# SERVICE BULLETIN

No.: SRE12-01  
Section: Recall  
Date: 19 MAR 2012  
Model: 1995 - 1999MY Discovery (LJ),  
1999 - 2004MY Discovery II (LT),  
1995MY Range Rover (LH)  
Market: USA

*Subject:* Notification of Safety Recall P024 (NHTSA # 12E010)

TVF100010 (1H2Z- 7123-AA)

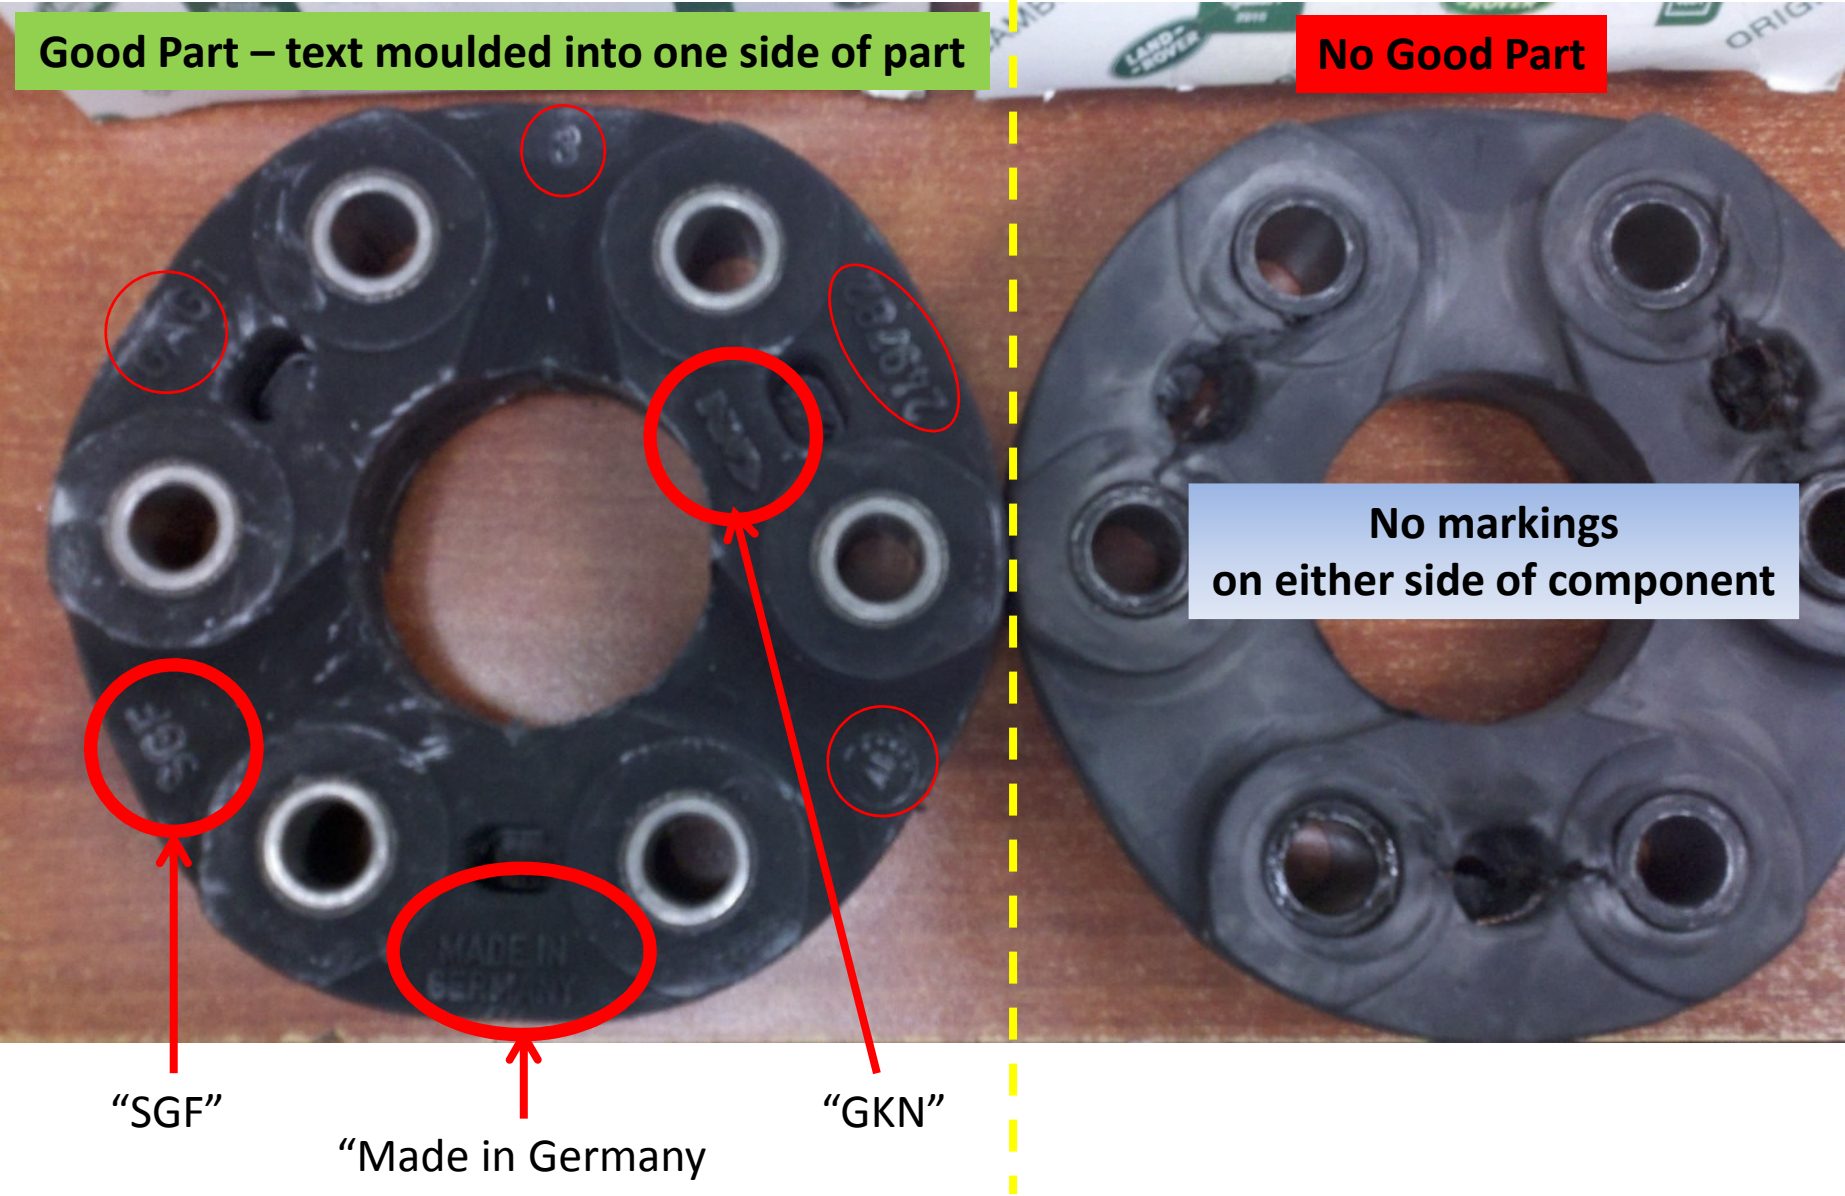
1. Check packaging label; if Vendor / Supplier Code is 'FA8FB', the component must be quarantined and must not be sold / utilized to affect vehicle repairs.
2. Check the component against the attached photo to further determine a 'good' / 'no good' condition, In the event of a 'no good' determination, the component must be quarantined and must not be sold / utilized to affect vehicle repairs.
3. In the event of a 'no good' determination in either step 1 or 2, the component must be immediately returned using return code 'ZRTN 020 – Faulty Material Number'.

Good Part – text moulded into one side of part

No Good Part

No markings  
on either side of component
